# TECHNICAL BULLETIN

## Climate Control System – Revised Pipe and Pressure Switch Location

82-45

MODEL Sedan (4.0) Range 1993-94 MY DATE 8/95  
with R-134a systems

ILLUSTRATION 1

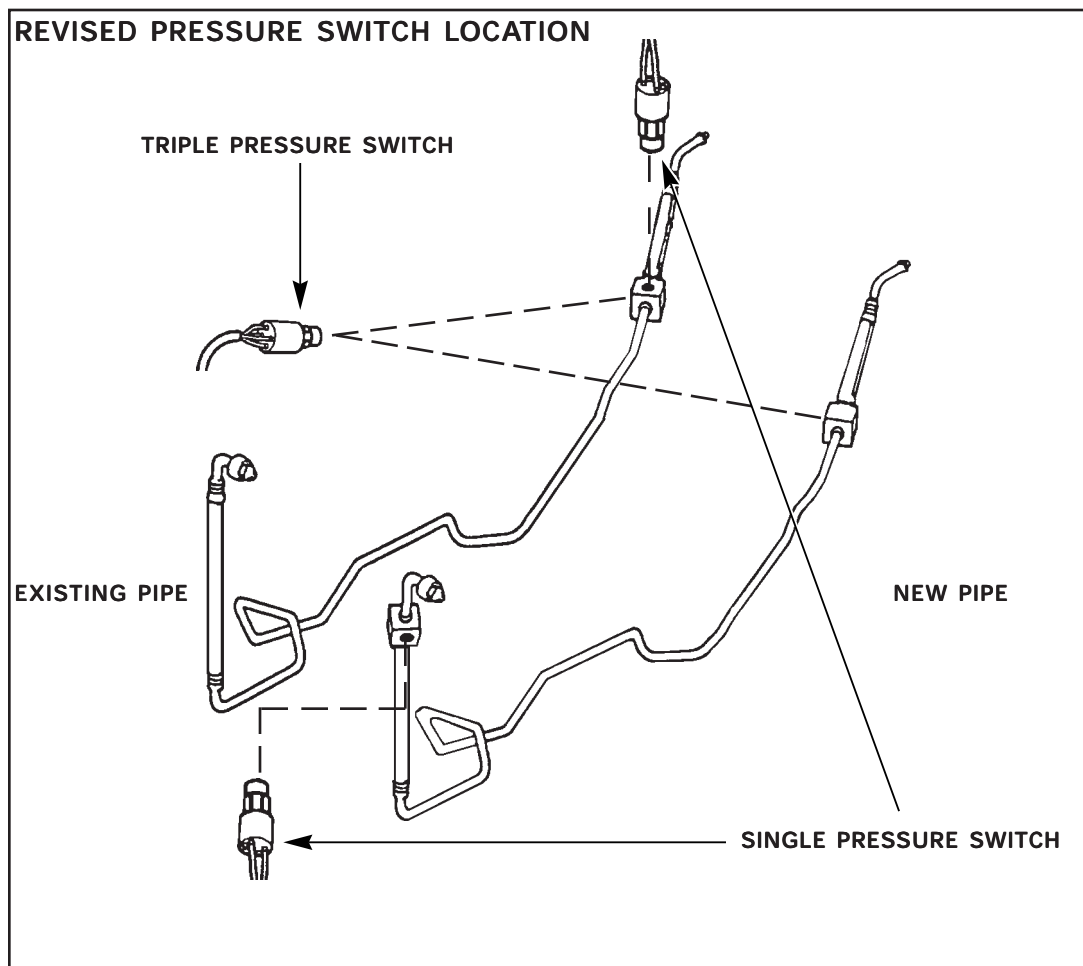
The high-pressure pipe from the condenser to the expansion valve has been superseded to part no. MMD-7360AB plus LMD 3997CA. This pipe separates the single pressure switch from the triple pressure switch to a location at the opposite end of the assembly. The triple pressure switch remains near the expansion valve, while the single pressure switch is relocated to the condenser end of the pipe, Illustration 1.

When installing the later style pipe (MMD-7360AB), obtain the link lead LMD-3997CA to connect the single pressure switch to the vehicle harness.
